APPLICATION NO.	FILING DATE	FIRST NAMED INVENTOR	ATTORNEY DOCKET NO.	CONFIRMATION NO.	
10/663,107	09/16/2003	Akihiro Tsuchizaki	032405.153	1813	
25461 759	90 01/13/2006		EXAMINER		
,	BRELL & RUSSELL,	STERLING, AMY JO			
1230 PEACHTE SUITE 3100, PE	REE STREET, N.E. ROMENADE II	ART UNIT	PAPER NUMBER		
ATLANTA, GA 30309-3592			3632		
			DATE MAILED: 01/13/2006

This is the **Final Office Action** for application number 10/663,107 License Plate Holding Bracket and the Holding Structure Thereof, filed on 9/16/03. Claims 1, 3-8, 10-21 are pending. This **Final Office Action** is in response to applicant's reply dated 10/21/05. The text of those sections of Title 35, U.S. Code not included in this action can be found in a prior Office action.

Claims 1, 3, 4 and 6 are rejected under 35 U.S.C. 102(b) as being anticipated by Japan 2004-182152 to Ofu.

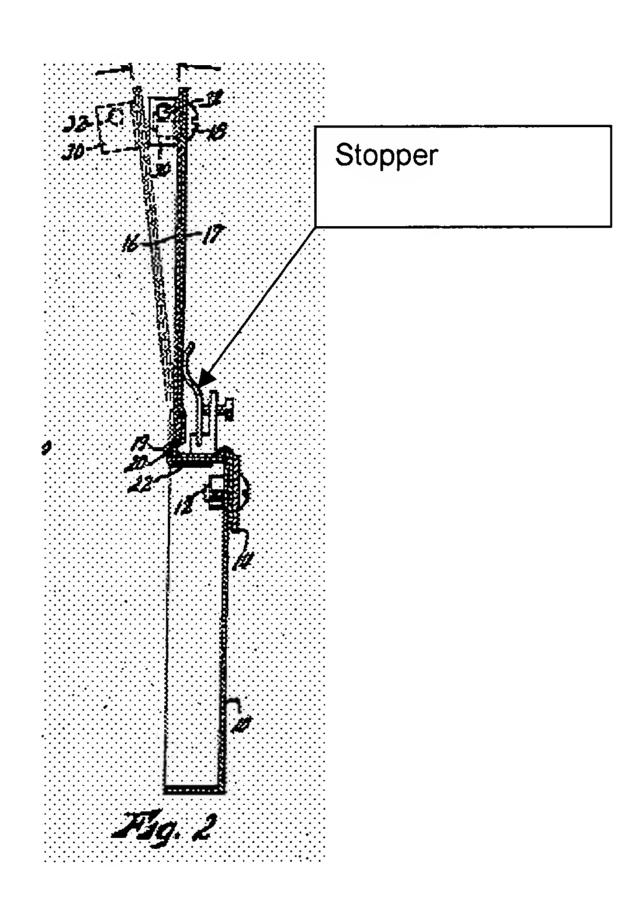
Ofu discloses a license plate holding bracket having a plain shaped gate side fixing member (20), a plain plate holding member (21) rotatably connected to the gate side fixing member (20) at an end side of the plate holding member which performs a reciprocal rotational movement, and a stopper (14) provided on the plate holding member. Ofu shows wherein the stopper 14 contacts both the bumper (See Fig.1) and the gate side fixing member (See Fig. 3).
